## GUYONG QUARRY – DETAILED RESPONSE TO PUBLIC EXHIBITION SUBMISSIONS

### Submission by RJ, MG, GJ Munro, 2 November 2009

### Submission by NSW Department of Industry and Investment

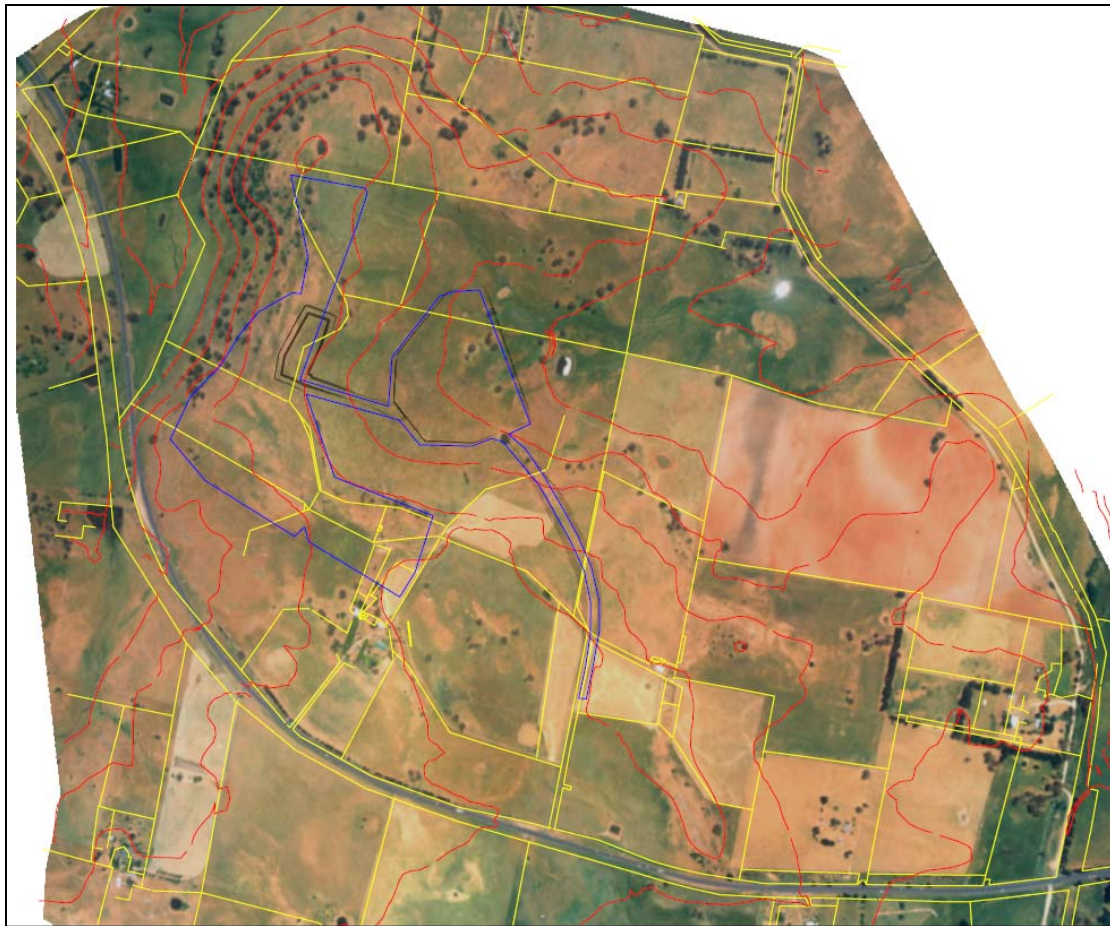
6. Blasting and excavating will completely change escarpment and entire area

The quarry pit will remove around 4 metres off only part of the top of the hill. The pit is then developed into a crater with a road access cutting through to the crushing plant on the east side. The below figures show an aerial view of the proposed quarry and the view from the Munro residence (Carina Vale).

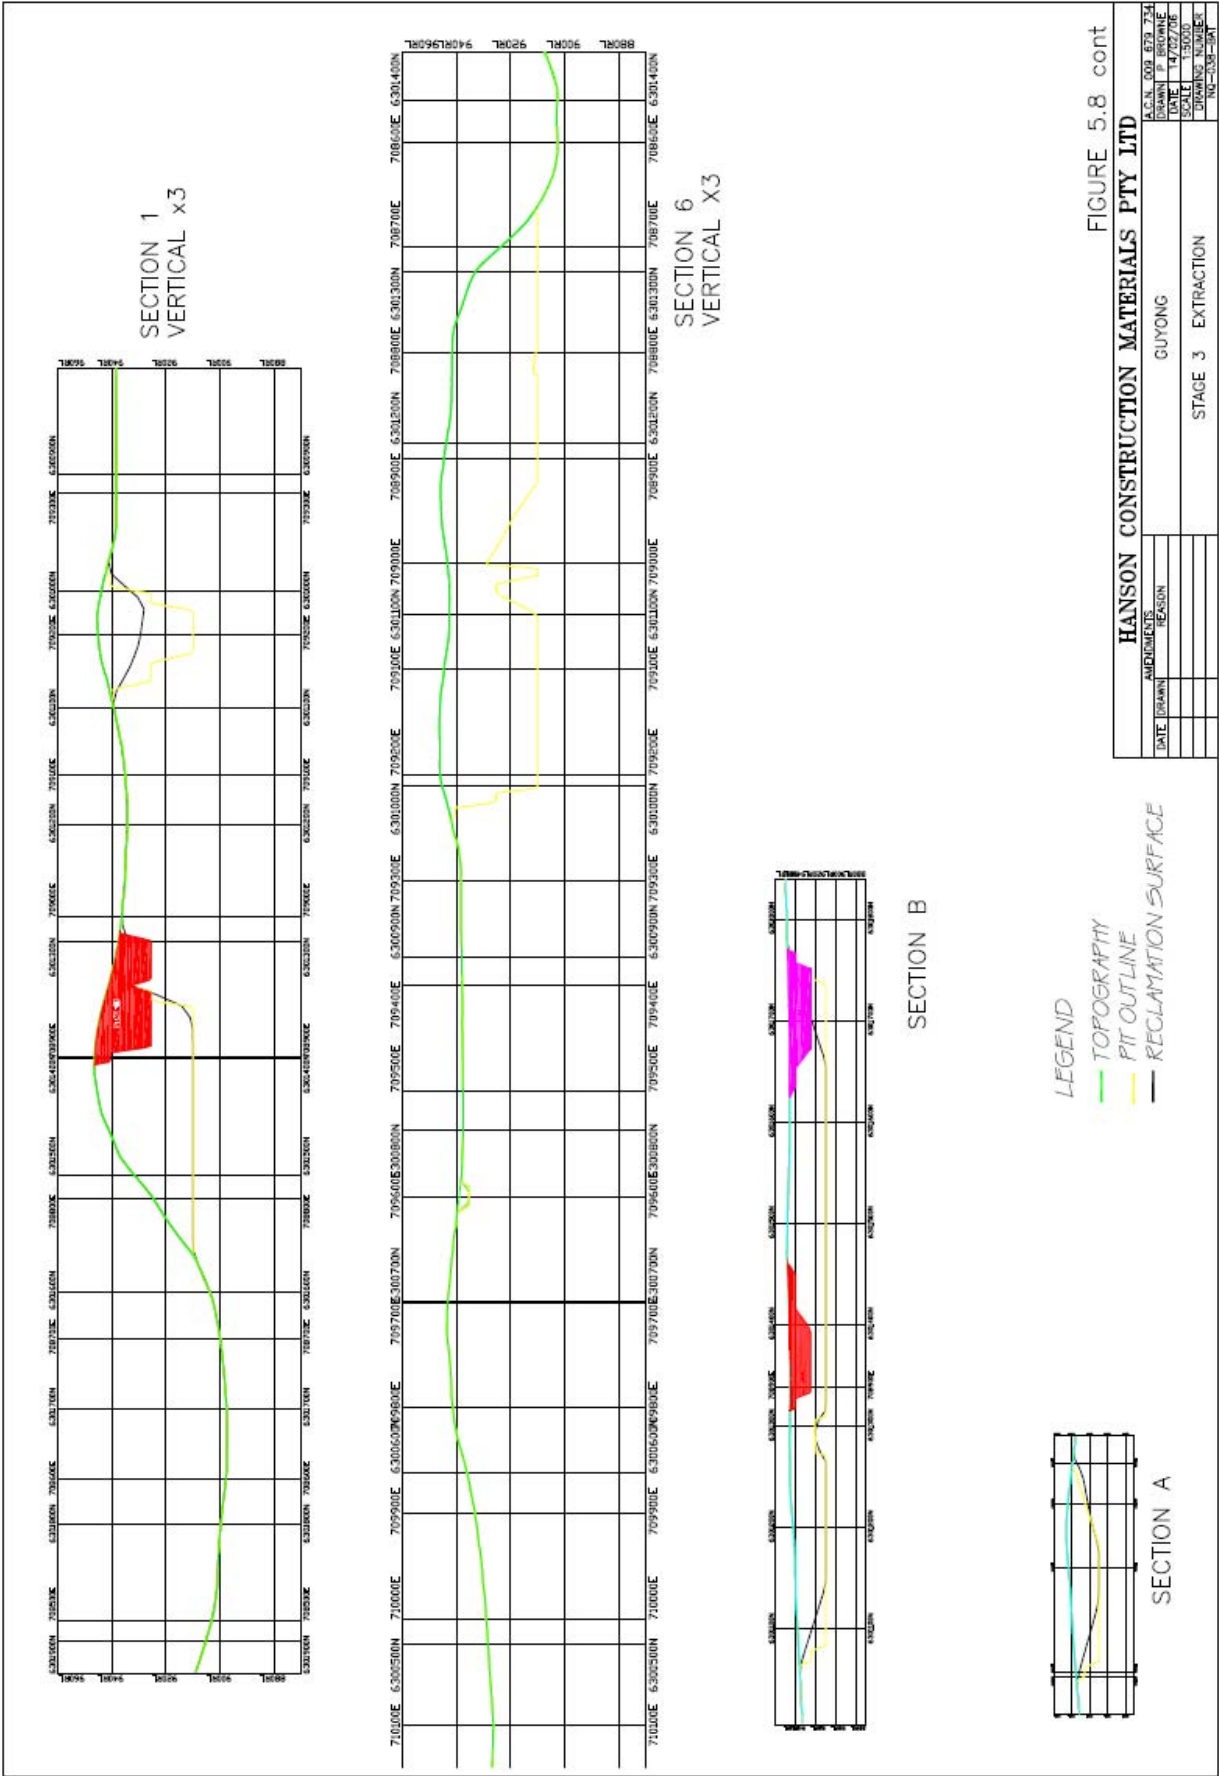
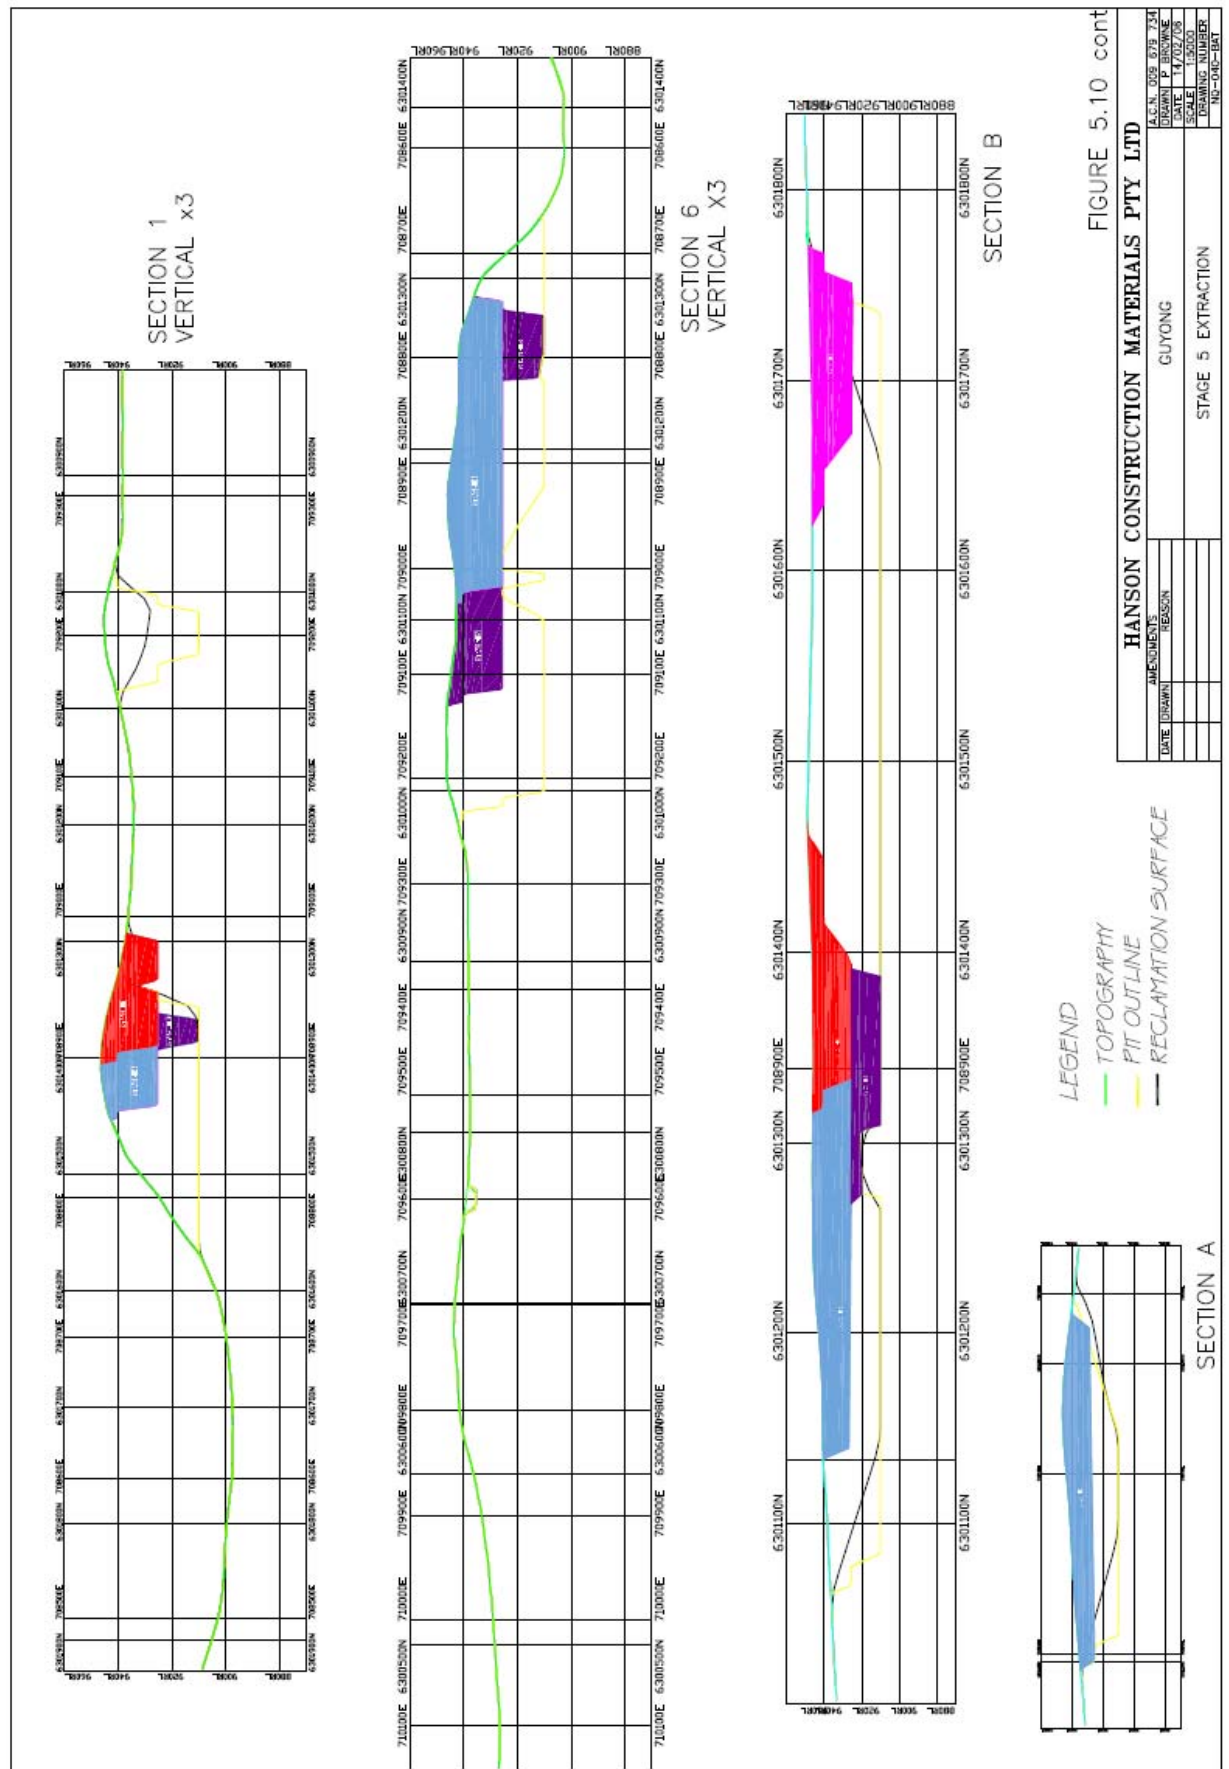
Figure 5.3 "Site Layout and Works Plan" on page 46 of Volume 1 of the EAR has been used to illustrate the location of the additional extraction areas and potential extraction area not geology or extraction stage cross sections. Figure 5.6 (not Figure 5.1) on page 56 of Volume 1 of the EAR illustrates Stage 1 of the quarry planning and development. As the extraction stages progress the following figures illustrate the development:

These figures are made up of a plan view and cross-section for each corresponding stage. The cross-sections shown for Figures 5.8, 5.9, 5.10 and 5.11 are incorrect as Section B does not show a change in pit development, and section 6 on Figure 5.8 shows the quarry pit being intersected at stage 3 when in fact it is not. The correct figures are shown below.

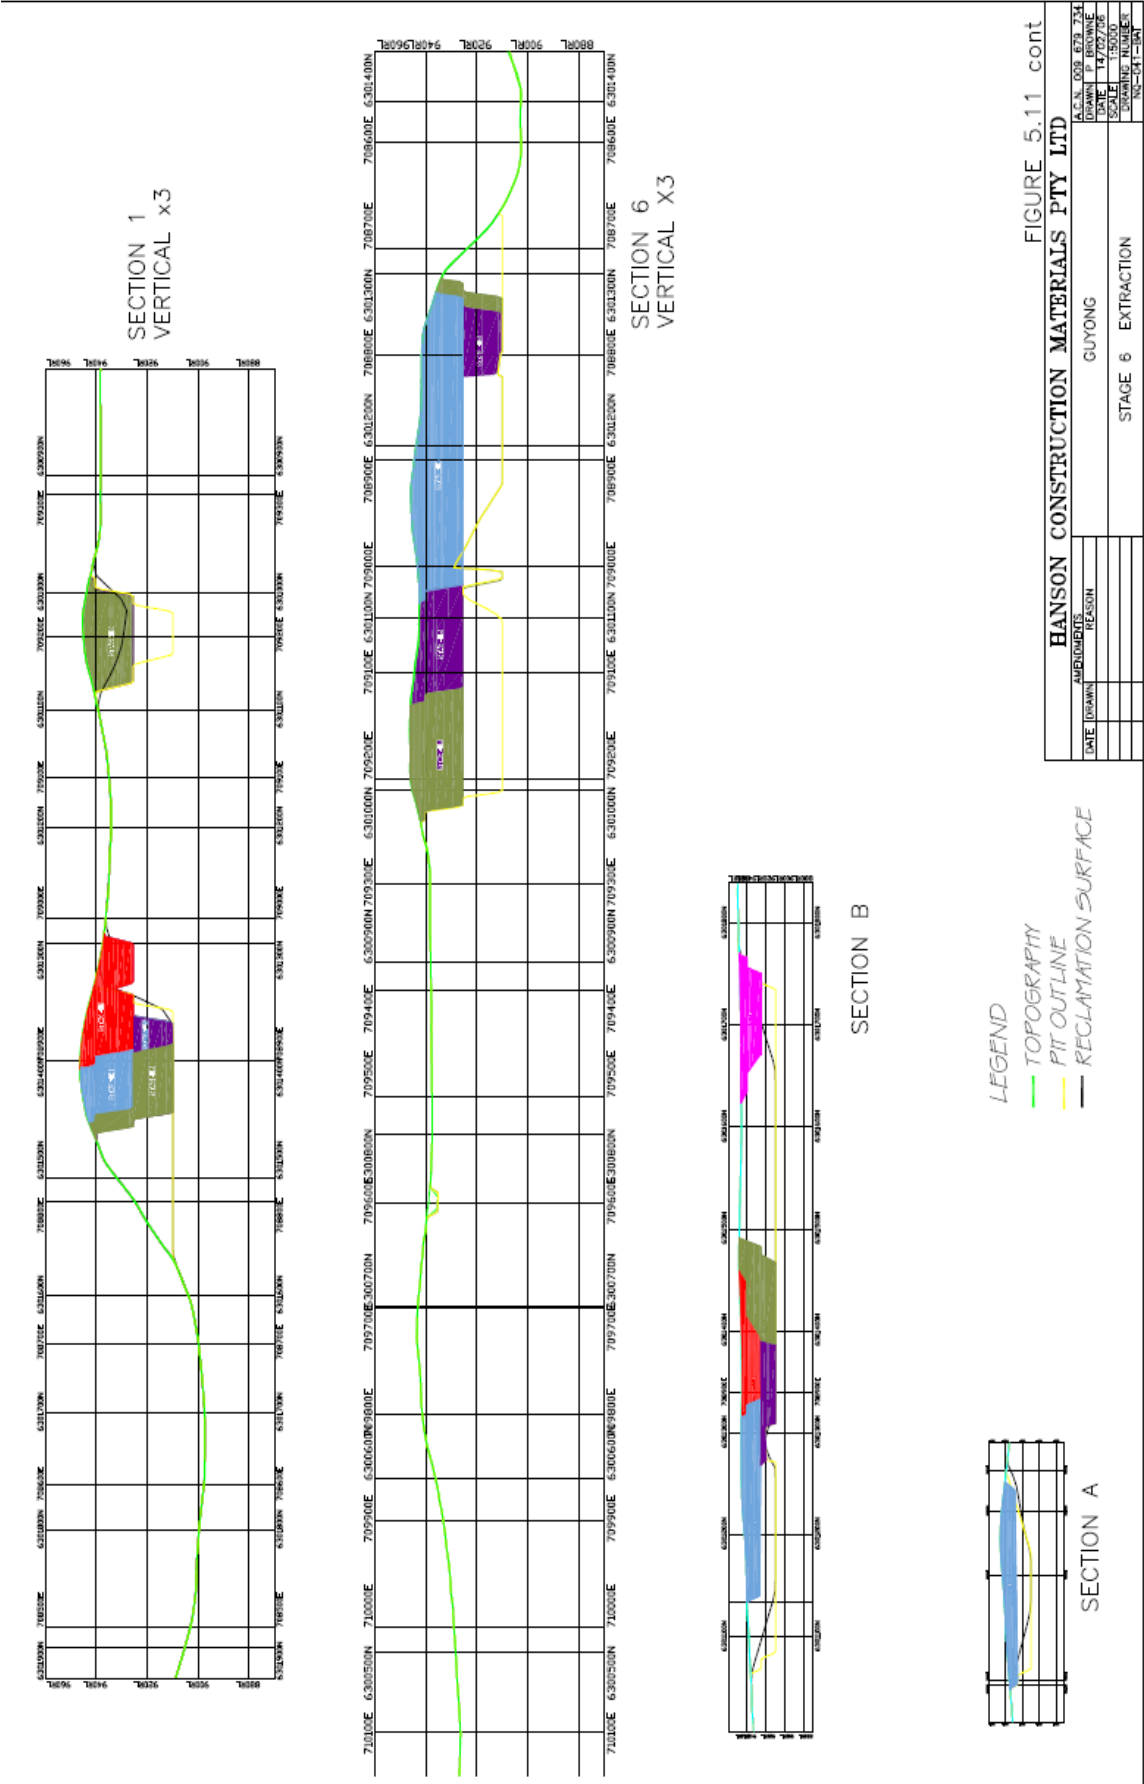
With regard to the Geology Resource section the Sections A, B, and C shown in Figure 5.1 correspond to Figure 5.1A shown below and not any other figures in the EAR. To help clarify the site geology in more detail the Geology Report produce by HCM in 2005 is attached in Annexure C.

Figure 1- RME, naturally occurring asbestos pit and mapping locations for the proposed quarry site.

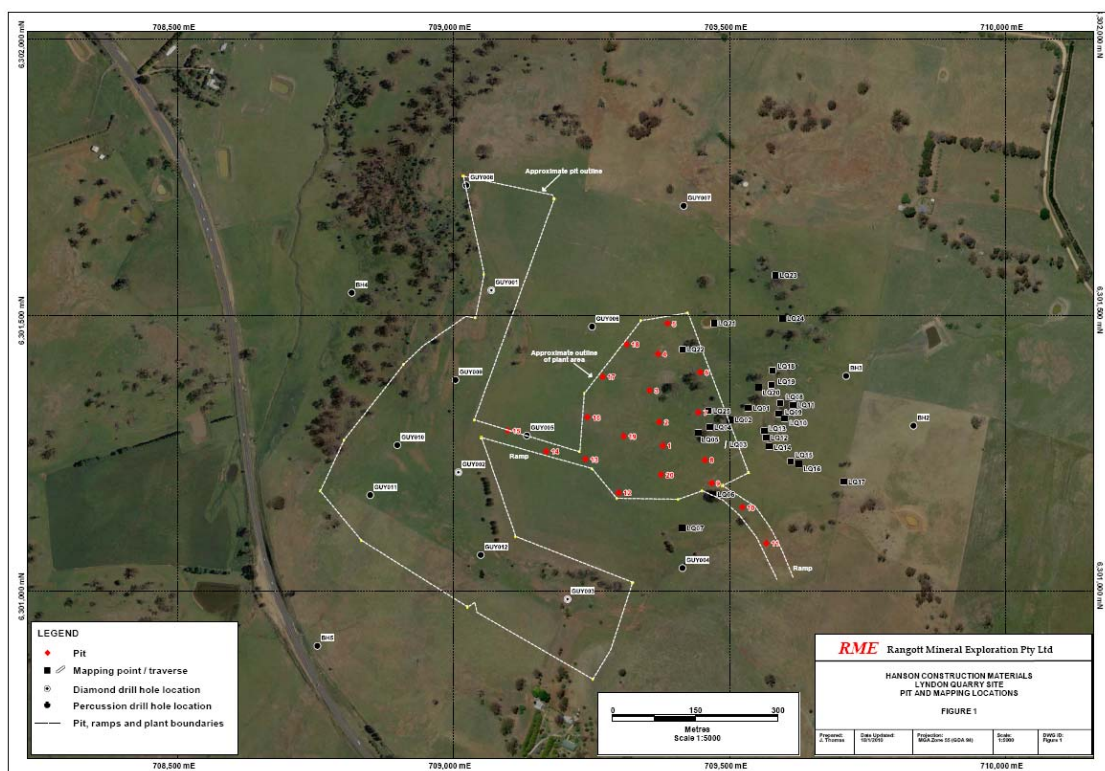
### 3. Asbestos Concern

The study involved geological mapping and sampling (on the surface, excavator dug pits, and examination of core holes) of the areas within and around the development envelope of the proposed quarry (see figure 1 below). The report concluded that the basalt in the proposed extraction quarry pit, where drilling and blasting will occur, does not contain asbestos. Based on this the risk associated with exposure to asbestos due to drilling and blasting within the quarry pit is negligible. The RME report indicates that the risk of encountering asbestos is increase further to the east away from the extraction area. The RME report has classified the areas of risk as shown in figure 2 below. In the western half of the proposed processing plant and stockpile area, there is an increasing thickness of cover of partly to deeply weathered Tertiary basalt. This cover material is unlikely to contain asbestiform minerals, except where mixing of Ordovician and Tertiary rock rubble may have occurred in the past. Tremolite asbestos has been detected in the Byng Volcanics rocks that are exposed sporadically along the eastern quarter of the proposed plant site, and for at least 150 metres to the east of the eastern boundary of the plant, and in all probability, are exposed much further to the east.

The mitigation strategies recommended in the RME report are:
